REMARKS

CERTIFICATE OF MAILING BY "EXPRESS MAIL" (37 CFR 1.10)			Docket No. 13902-1	
Applicant(s): LOU, et al.				
Application No. 10//065,375	Filing Date October 10, 2002	Examiner PHAN, Raymond	Customer No. 23676	Group Art Unit 2111
Invention: Signal Switch for Console and Peripheral Devices

Office Action Summary

Part III DETAILED ACTION

Fig. 1

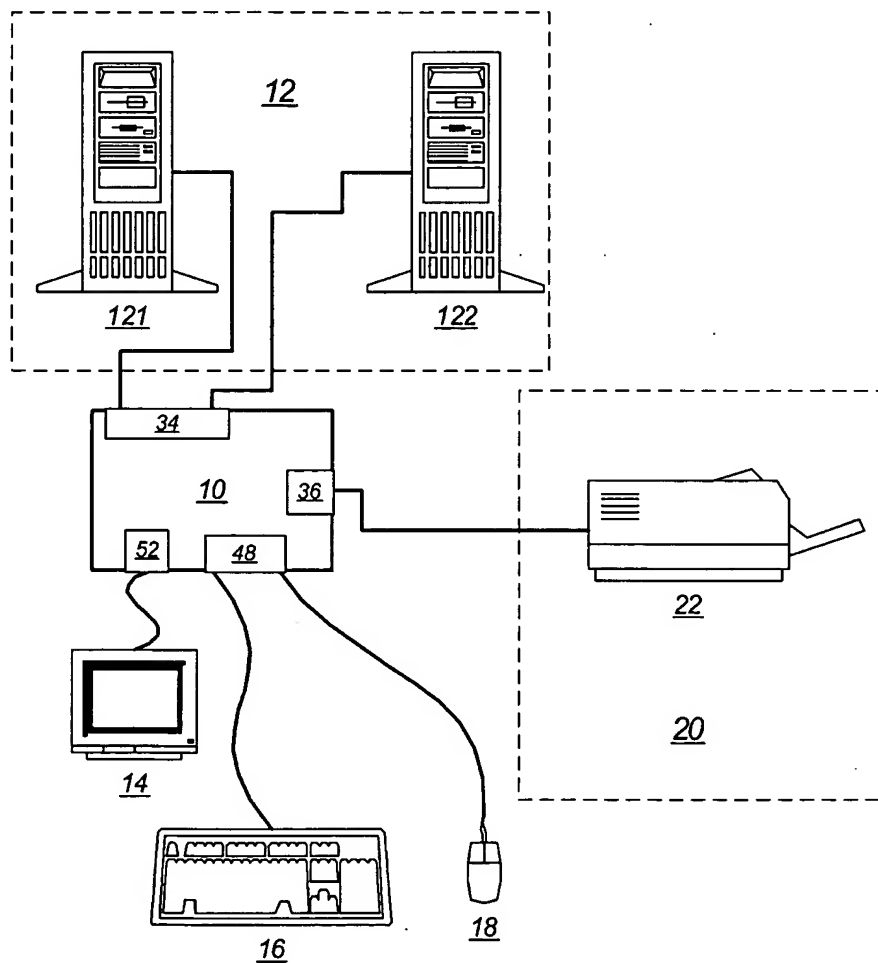
Dickens et al. teaches a routing device, not a switching device. A simple example will demonstrate the difference between Dickens et al. and the present invention. Figure 1 from the present invention is as follows:

Here, the console devices are keyboard 16, mouse 18, and video monitor 14. The peripheral device is first printer 22. There are first computer 121 and second computer 122. By way of example, suppose that in an initial state, console devices (14, 16, 18) and printer 22 are connected to first computer 121, which is sending a signal through switch 10 to printer 22 (a document being spooled, for example). The user now switches to a second state, in which switch 10 synchronously connects console devices (14, 16, 18) and printer 22 to second computer 122. The data stream coming from first computer 121 at the time of the switching is left unaffected (the document being spooled finished printing), but otherwise printer 22 is now connected to second computer 122:

In contrast, Dickens et al. functions like a router, *e.g.*, more like a network. Switch 10 of the present invention is replaced by a data routing device 100. Dickens et al. teach a system of arbitration to avoid conflicts when the computers send data to the printer:

Dickens et al. do not allow the user to switch the peripherals synchronously with the console devices; rather they remain connected to a “network” and the host computers contend for the channel to the peripheral independent of the console device connections. Therefore, Dickens et al., neither alone nor in combination with Thomas et al., teach or fairly suggest switching the console devices either synchronously or asynchronously with one or more peripheral devices to the same one of a plurality of computer systems, or to different ones of the plurality of computer systems, without interruption of the signal to the one or more peripheral devices.”
